FINAL ENVIRONMENTAL IMPACT REPORT

Plan BayArea 2040

Metropolitan
Transportation
Commission

Association
of Bay Area
Governments

Revised Figure 1.2-2
Transit Priority Areas, Priority Development Areas, and
Priority Conservation Areas

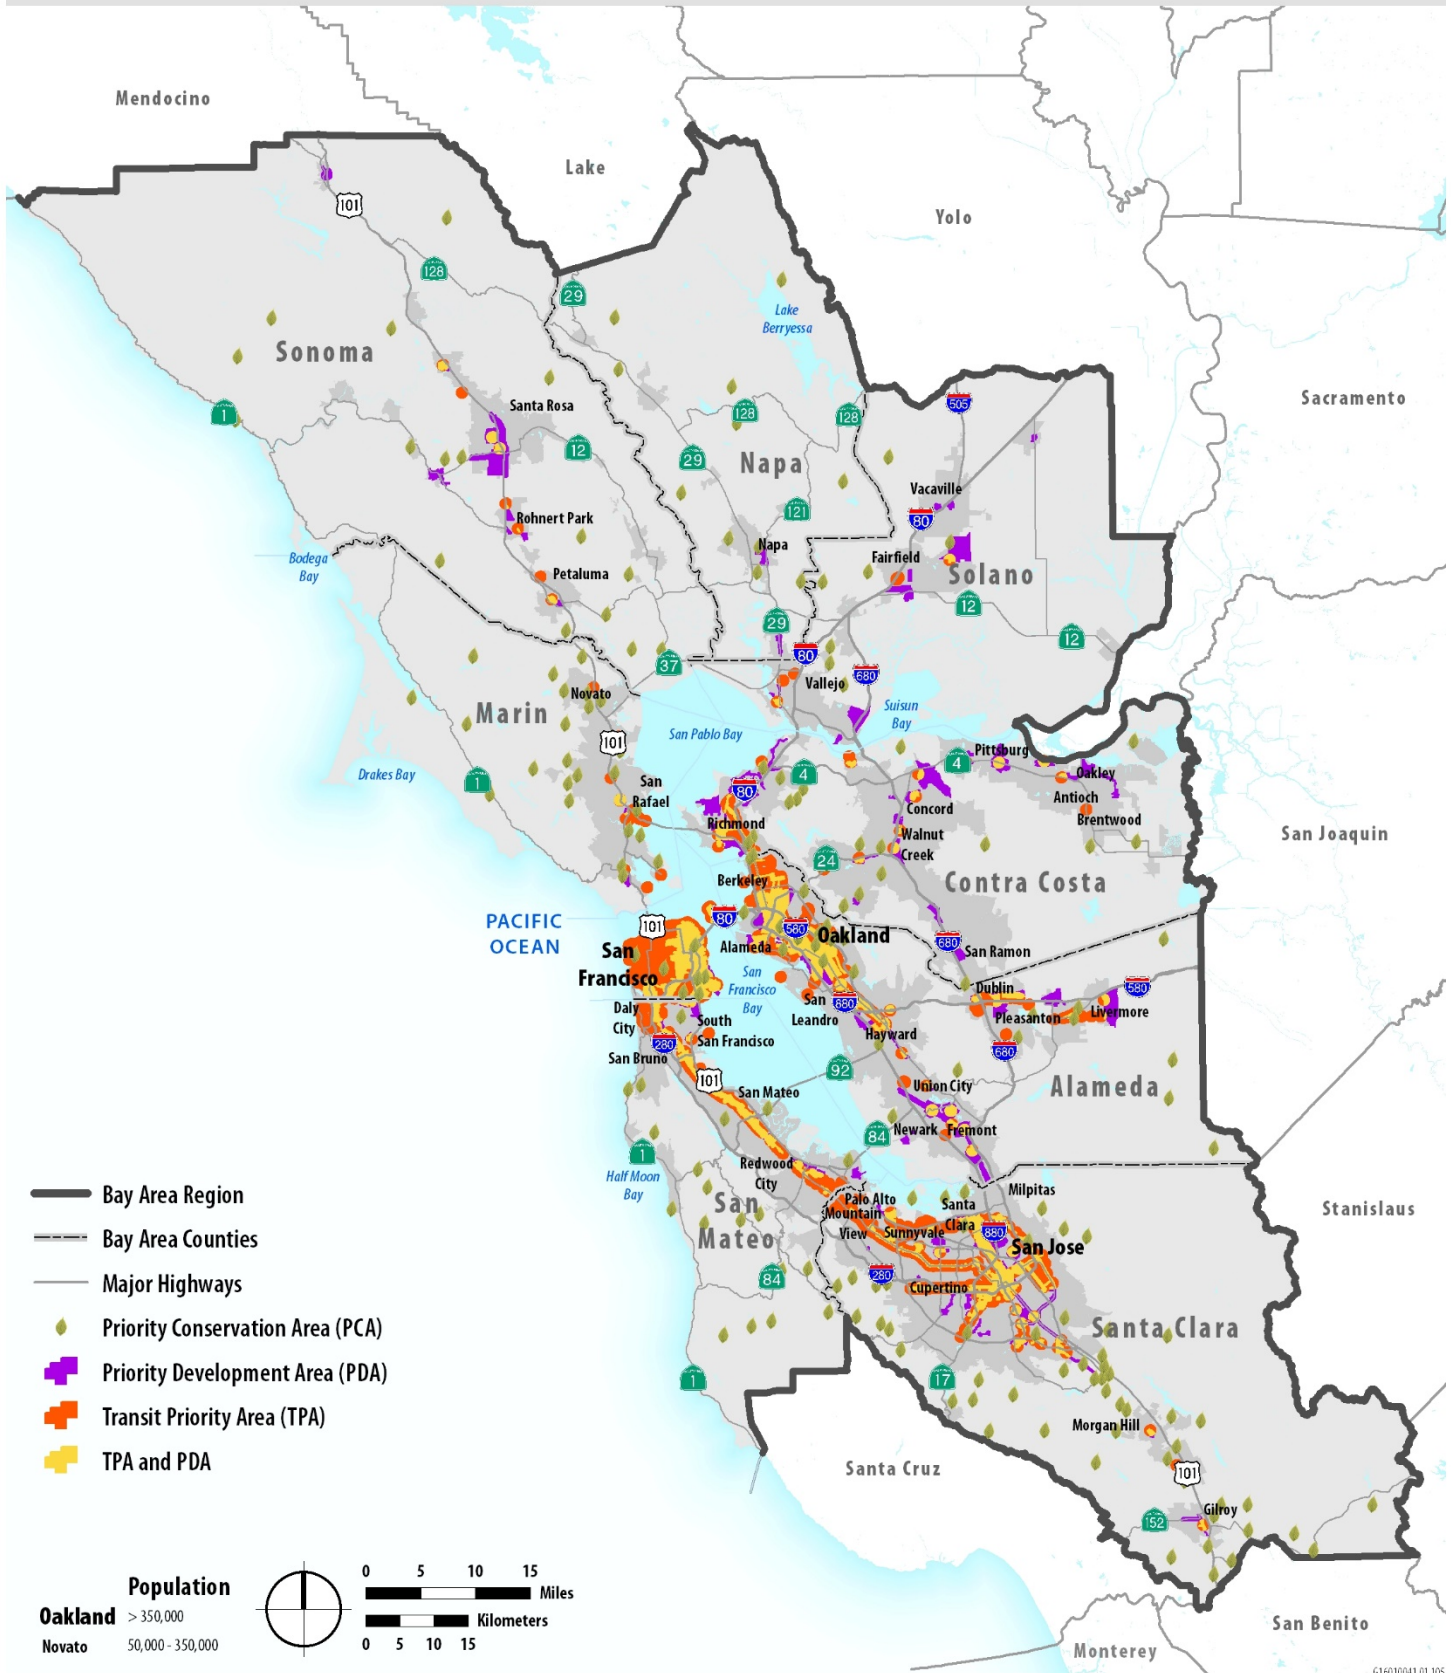
Page 1.2-20 – The text on page 1.2-20, Figure 1.2-2 of the Draft EIR has been revised as follows by MTC/ABAG staff:
